ARCHITECT'S SUPPLEMENTAL INSTRUCTIONS

PROJECT - (name, address)	**SURGERY CENTER OF LEE'S SUMMIT** 1318 E. 104th St. Kansas City, MO 64131	**ARCHITECT'S SUPPLEMENTAL INSTRUCTION NO. - (6)**	**6**
OWNER -	**Hammes Partners** 1400 N. Water Street, Suite 500 Milwaukee, Wisconsin 53202	**DATE OF ISSUANCE -** April 29, 2024	
TO - (Contractor)	**JE Dunn Construction** 1001 Locust St Kansas City, MO 64106	**ARCHITECT -**	ACI Boland, Inc. 1710 Wyandotte Kansas City, MO 64108
CONTRACT DATED -		**ARCHITECT'S PROJECT NO. -**	3-22030

Description -
ASI 06 captures changes to the documents that support RFI responses, specifically regarding RFI 46. Which include modifications to the exterior canopies to conceal the dry-pipe sprinkler system. In addition, interior changes include mock-up changes to the OR's, Scope Processing area, Sterile Assembly, and Prep/Recovery Bays.

1 FIRST FLOOR GAS AND VACUUM PLAN - AREA A
SCALE: 1/4" = 1'-0"

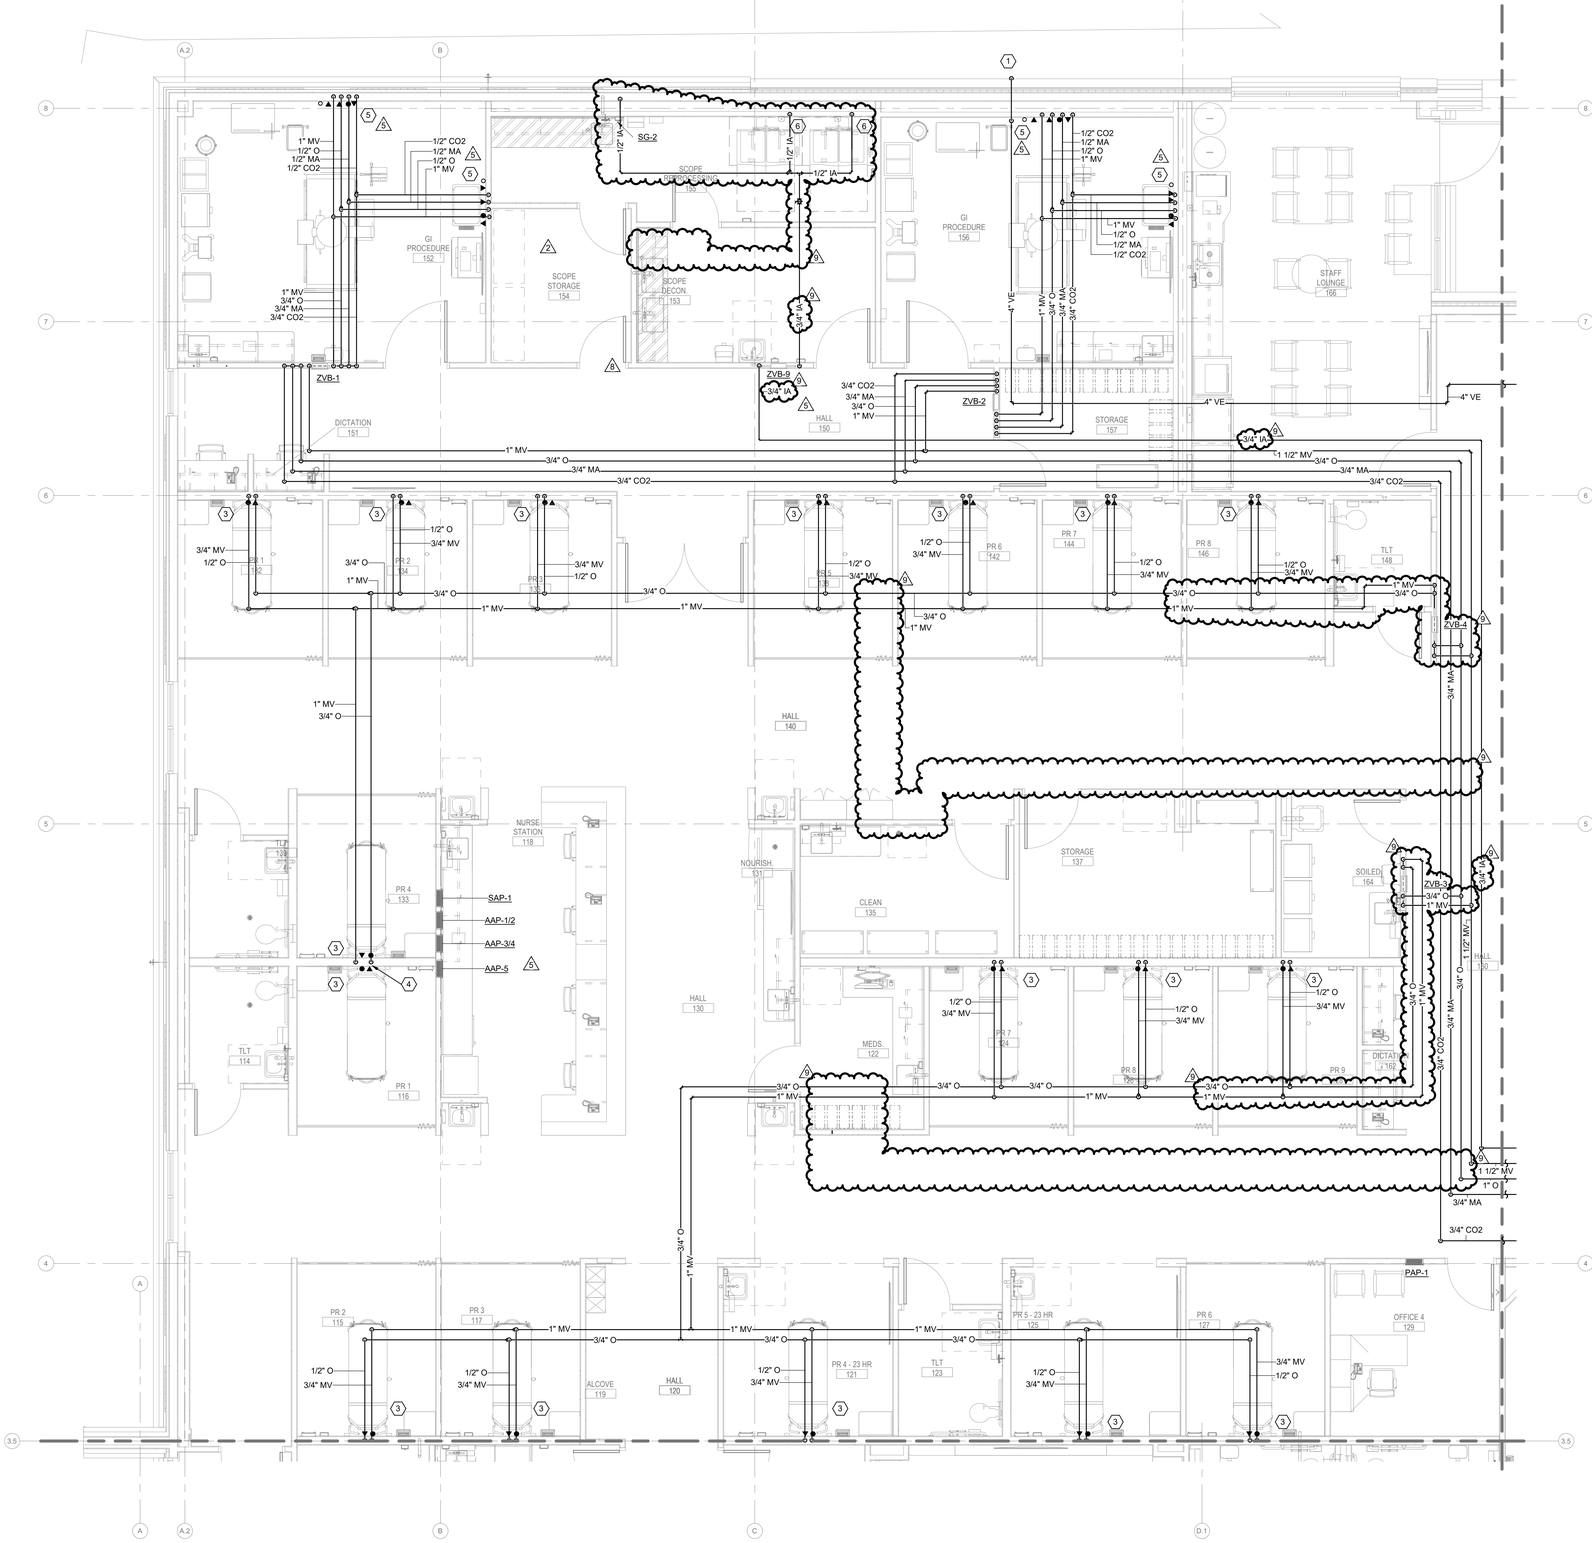
a. Moved ZVB-3 and ZVB-4 per RFI 071. Updated source side and patient side piping serving these new valve locations.
b. Updated Instrument air sizing for new demand.
c. Added ¾" branch from ZVB-9 to serve the Scope Reprocessing room with an instrument air connection to each medivator and a new SG-2 at sink.
d. Added note #6 and added to medivators.
e. Removed SG-2 from Scope Decon 153 per owner request.

1 FIRST FLOOR GAS AND VACUUM PLAN - AREA B
SCALE: 1/4" = 1'-0"

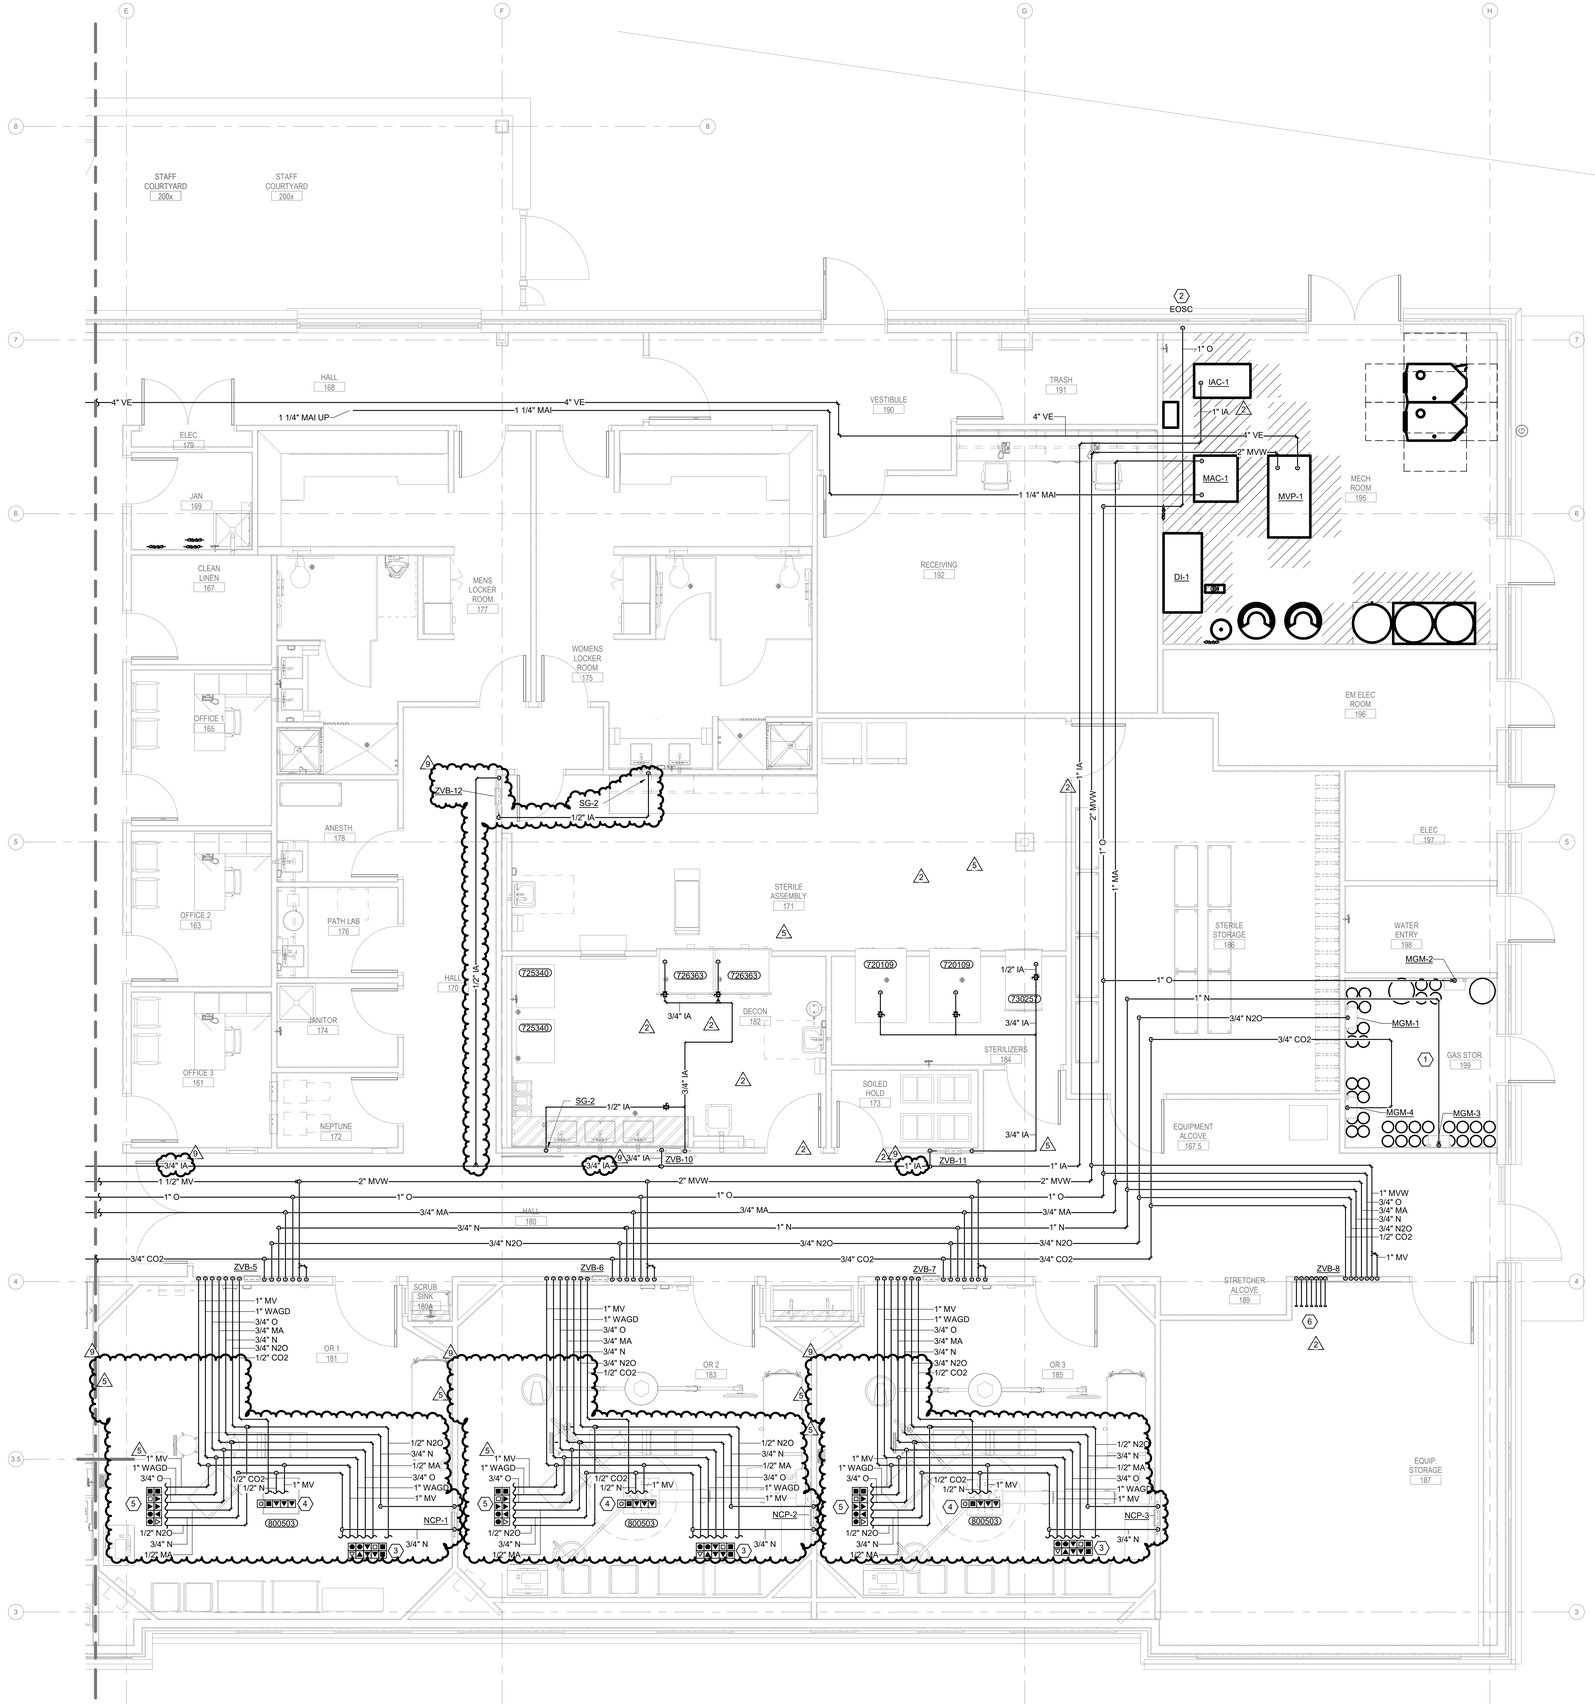
a. Added Instrument Air branch from main to ZVB-12 for Sterile Assembly instrument air, and added an SG-2 to the countertop as requested by owner.
b. Updated sizing of the instrument air main in Hall 180.
c. Updated Operating room med gas pipe routing and outlet locations per notes taken in the field.
d. Updated Note 4.
e. Moved CO2 outlet to Surgical Boom from overhead outlets as requested in markups.

A1 FIRST FLOOR POWER PLAN OVERALL

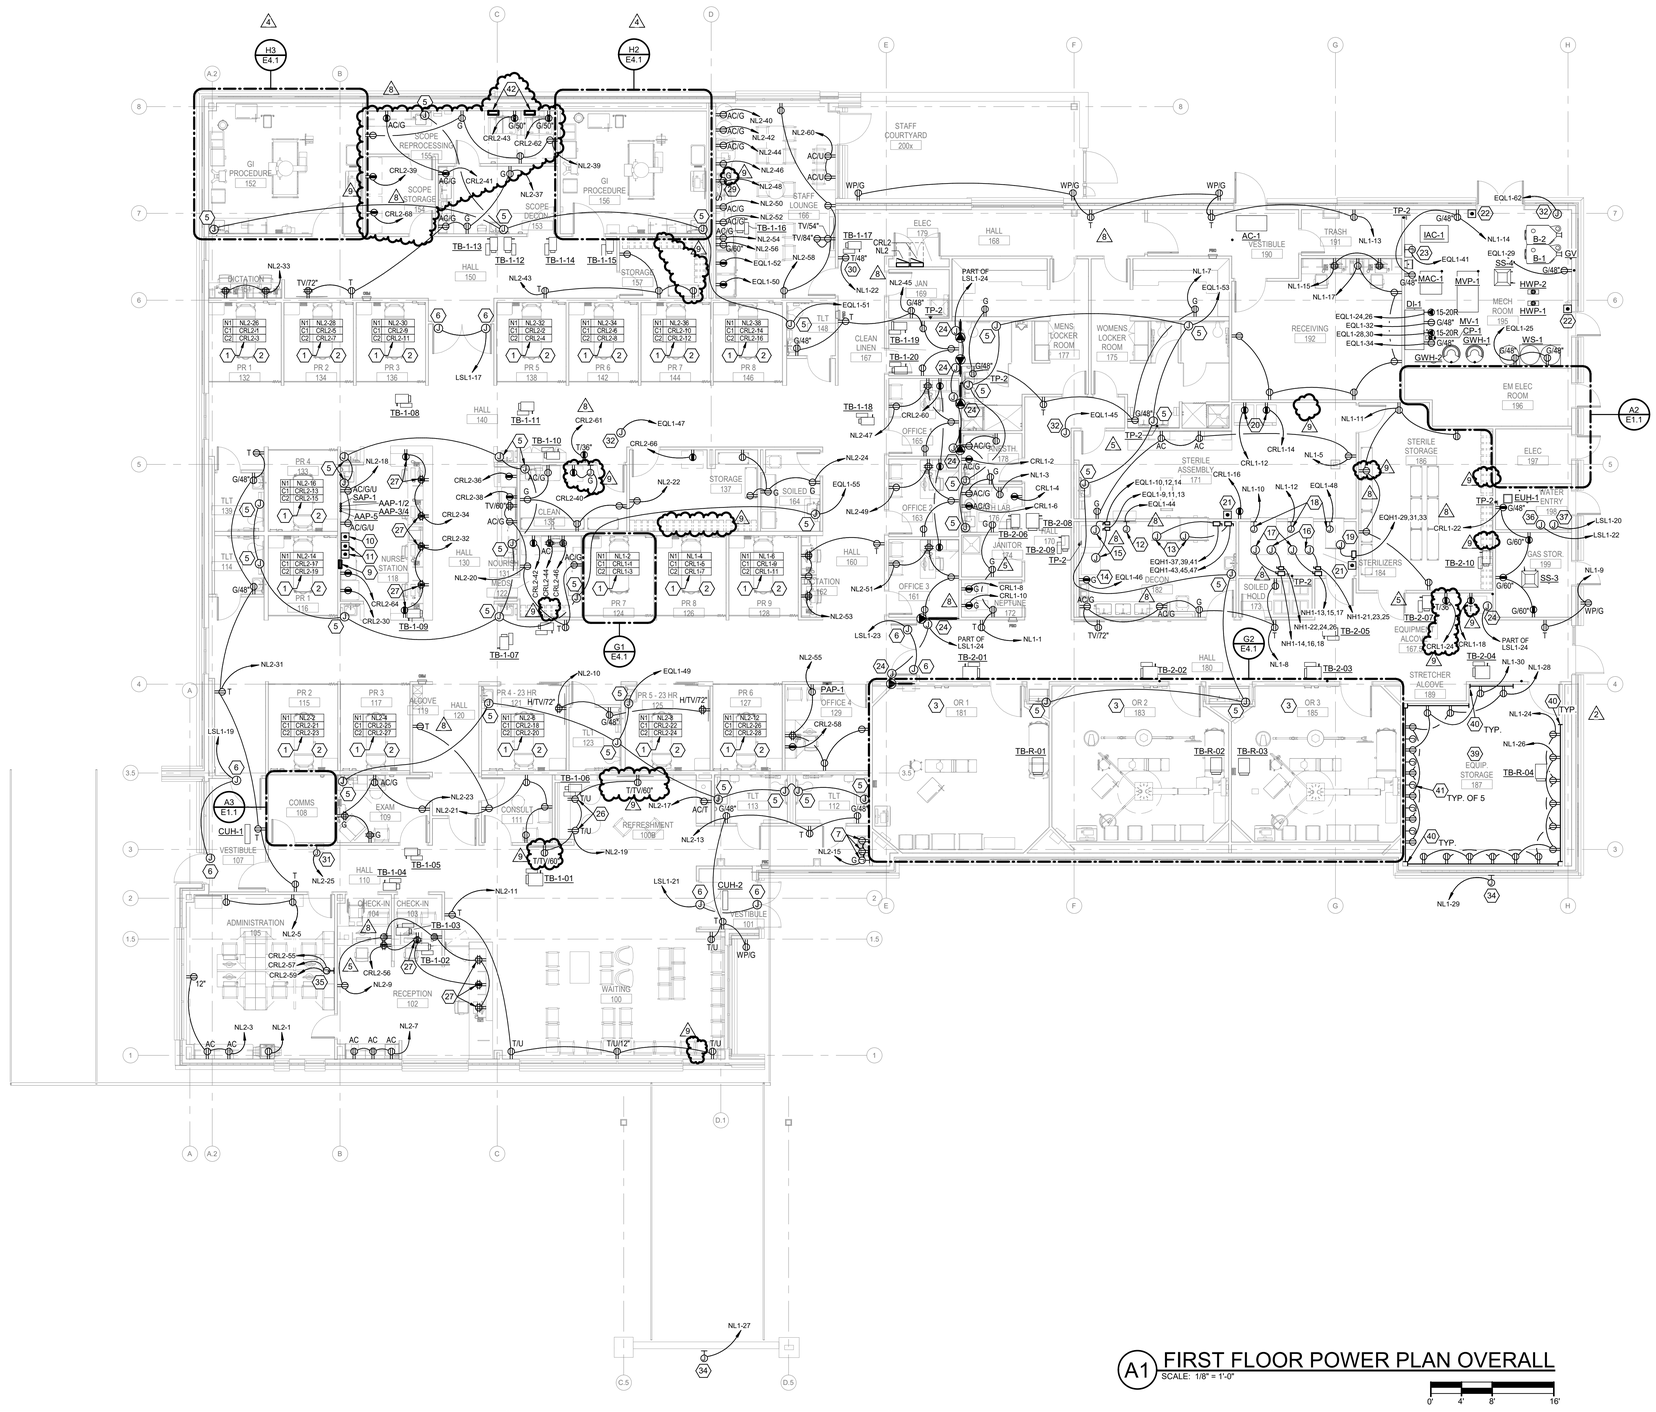
- **a.** Removed TV receptacle in Waiting 100.
- **b.** Revised TV receptacle locations near Refreshment 100B.
- **c.** Revised receptacles in Scope Reprocessing 155.

- **d.** Added keynote 42, noting to provide UPS for medical equipment in Scope Reprocessing 155.
- **e.** Revised location of receptacle serving scope drying cabinet to Scope Storage 154.

- **f.** Added receptacle for additional scope drying cabinet in Scope Storage 154.
- **g.** Revised location of receptacle in Storage 157.
- **h.** Removed receptacle in Storage 157.

- **i.** Revised receptacle serving garbage disposal to be GFCI type in Staff Lounge 166.
- **j.** Removed receptacle in Meds 122.
- **k.** Removed receptacles in Storage 137.

- **l.** Added dead-front GFCI device and revised receptacle in Clean 136.
- **m.** Removed receptacle in Sterile Assembly 171.
- **n.** Revised location of receptacle in Sterile Storage 186.

- **o.** Removed receptacle in Sterile Storage 186.
- **p.** Revised receptacle to be tamper resistant type in Equipment Alcove 167.5.
- **q.** Added receptacle and circuit in Equipment Alcove 167.5.

- **r.** Revised keynote 23.

1 FIRST FLOOR LIGHTING PLAN OVERALL
SCALE: 1/8" = 1'-0"

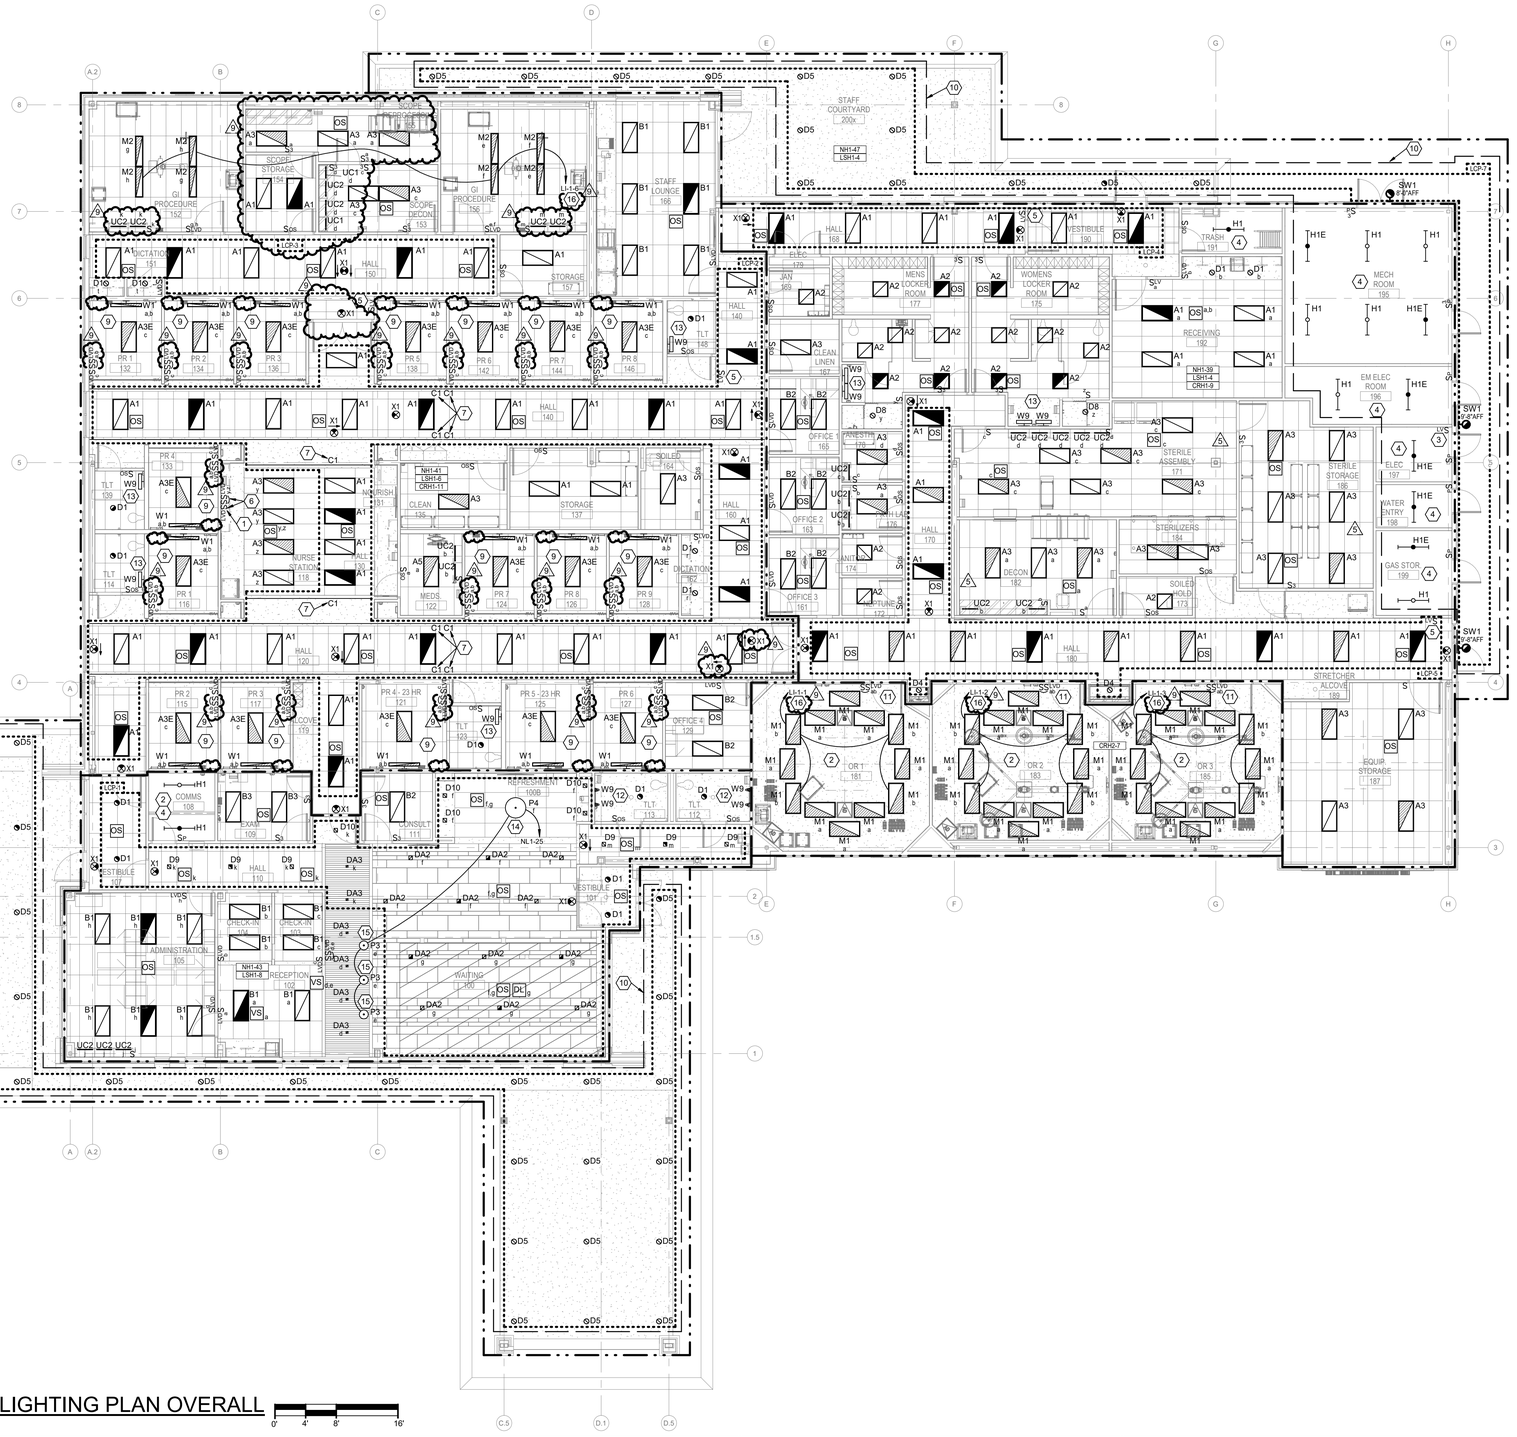
a. Added exit signs at intersection of Hall 120 and Hall 160.
b. Revised light fixture layout and controls locations in Scope Storage 154 and Scope Reprocessing 155.
c. Revised light fixture and exit sign location in Hall 150.
d. Added undercabinet light fixtures in GI Procedure 152 and GI Procedure 156.
e. Revised light switch location in each Prep/Recovery room.
f. Added keynote 16 to inverter lighting circuits.
